Subject: Oconee Nuclear Station  
Licensee Fees Pursuant to  
10 CFR 170.21

**INTEGRATED REACTOR VESSEL MATERIAL  
SURVEILLANCE PROGRAM  
(Addendum)**

BAW-1543A, Rev. 2  
Addendum 1  
November 1987

SUBJECT: REVIEW OF PROPOSED REVISION TO THE BABCOCK & WILCOX OWNERS GROUP  
INTEGRATED REACTOR VESSEL MATERIAL SURVEILLANCE PROGRAM.

Figure 2-1. Crystal River-3 IRVSP Schedule

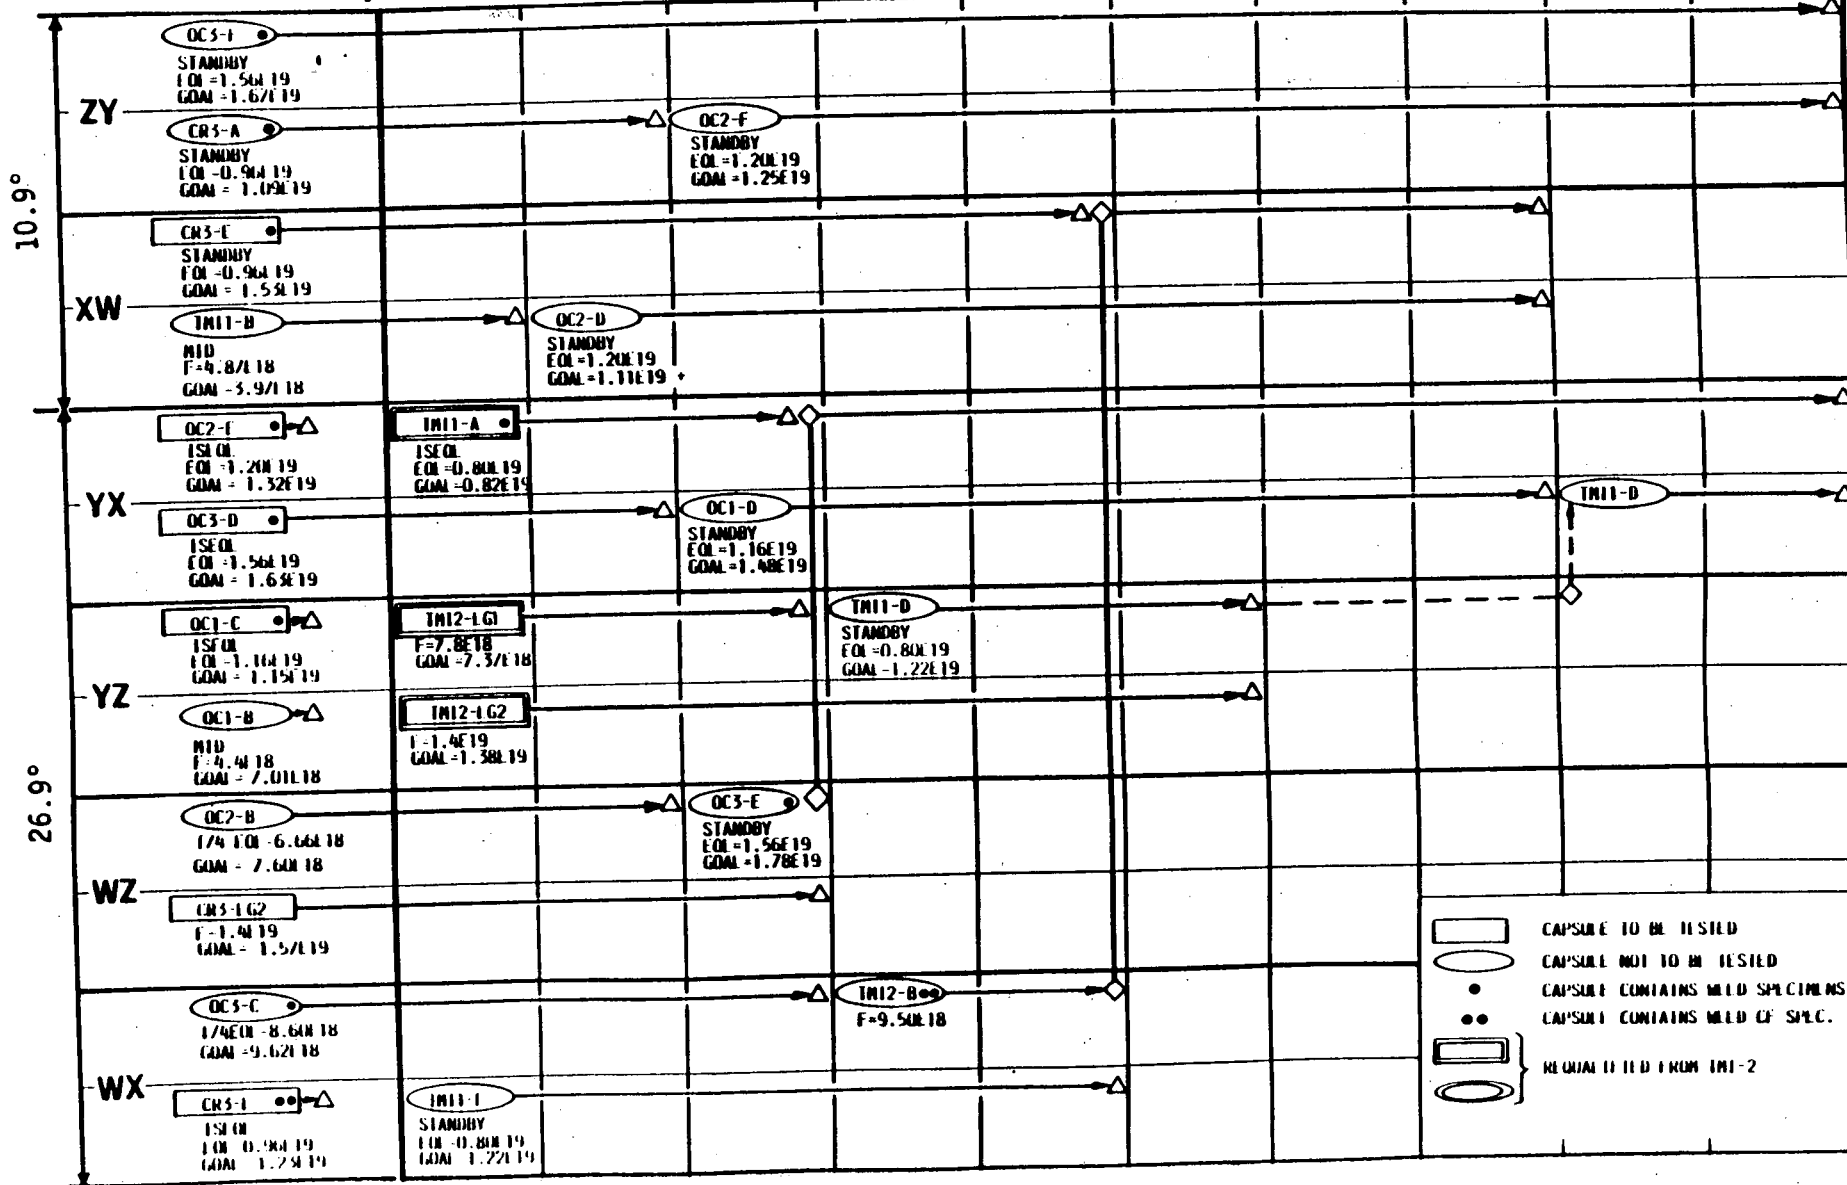
This addendum to BAW-1543, Rev. 2, provides a revised insertion and withdrawal schedule for surveillance capsules in the Crystal River-3 and Davis-Besse reactors. Extensive changes are made in the irradiation schedule starting with the next refueling outages:

The revised insertion and withdrawal schedule for irradiation capsules in Crystal River-3 is presented in Table 2-1 and Figure 2-1. The revised insertion and withdrawal schedule for irradiation capsules in Davis-Besse is presented in Table 2-2 and Figure 2-2. A summary of the status of all irradiation capsules currently in the integrated reactor vessel surveillance program is presented in Table 2-3.
